Variance Request Form

PG&E Hollister 115 kV Power Line Reconductoring Project

**Hollister 115 KV Reconductoring Project
Replace Switch on Existing Lattice Steel Structure**

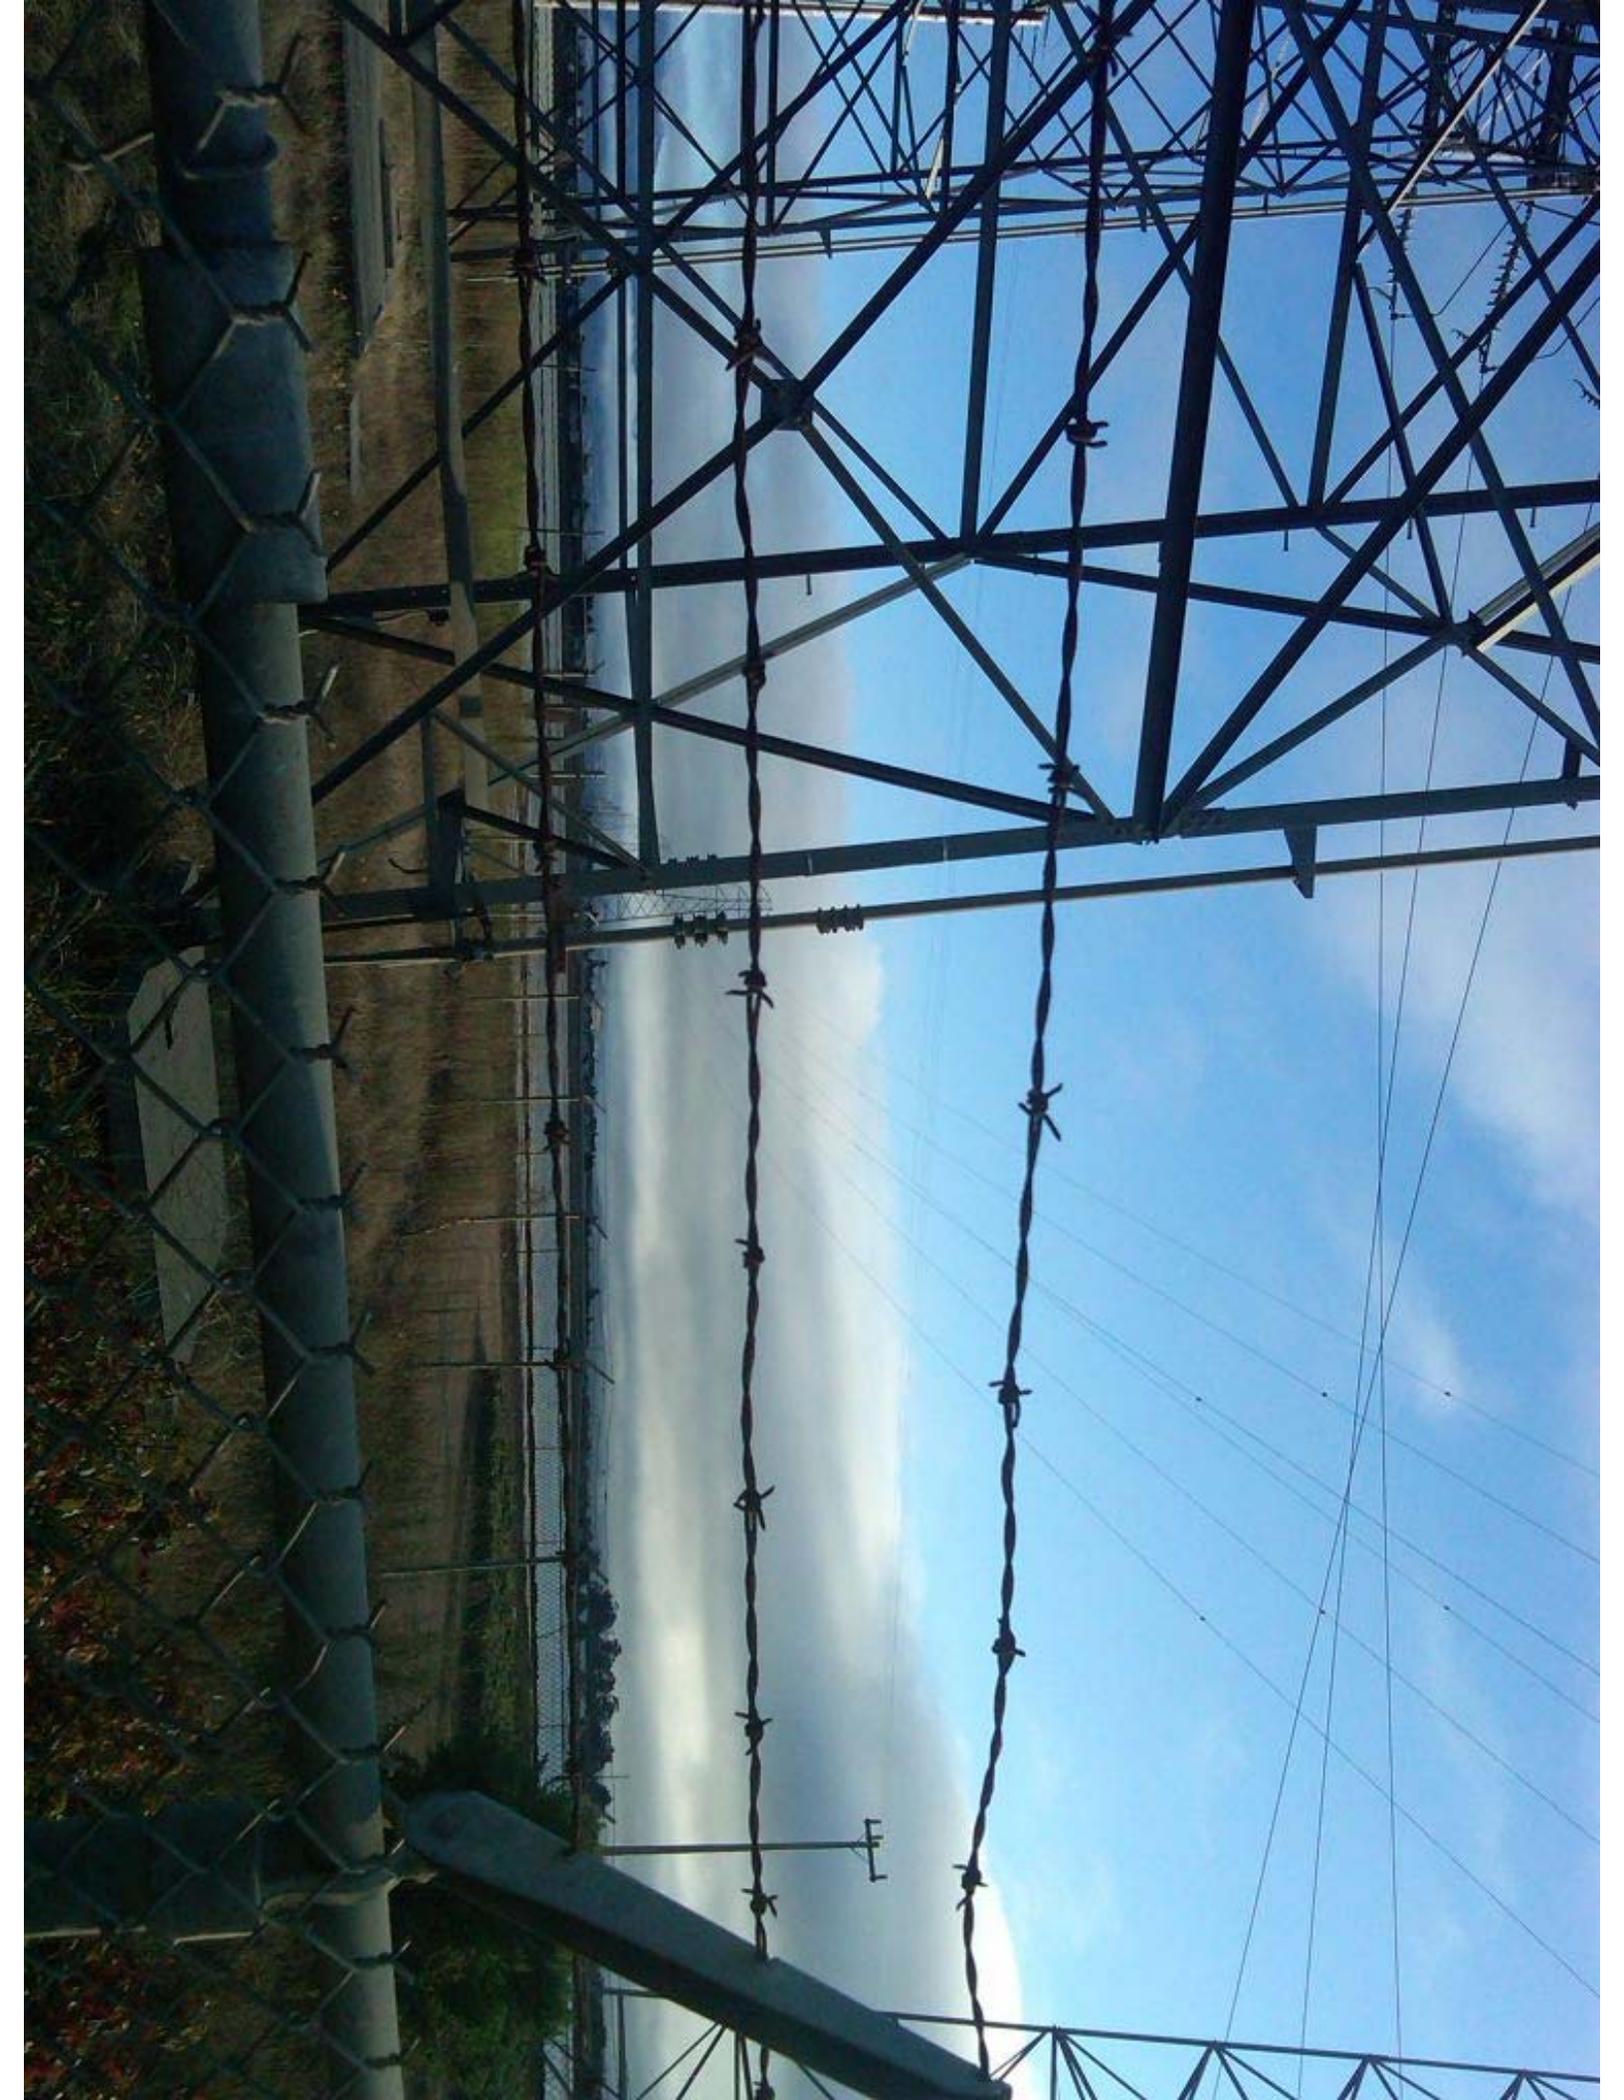
Replace existing non-working switch (commonly known as Natividad switch No. 119) attached to existing lattice steel structure with a new switch at a location approximately 3500 feet westerly of Old Stage Road and approximately 3500 feet northerly of East Boronda Road just north of the City of Salinas. The existing lattice steel structure is located adjacent to an existing farm road in a fenced area previously used as a PG&E switch station, and is surrounded by an actively farmed agricultural area (currently strawberry row crops). No ground penetration. Access to the structure will be the only ground disturbance.
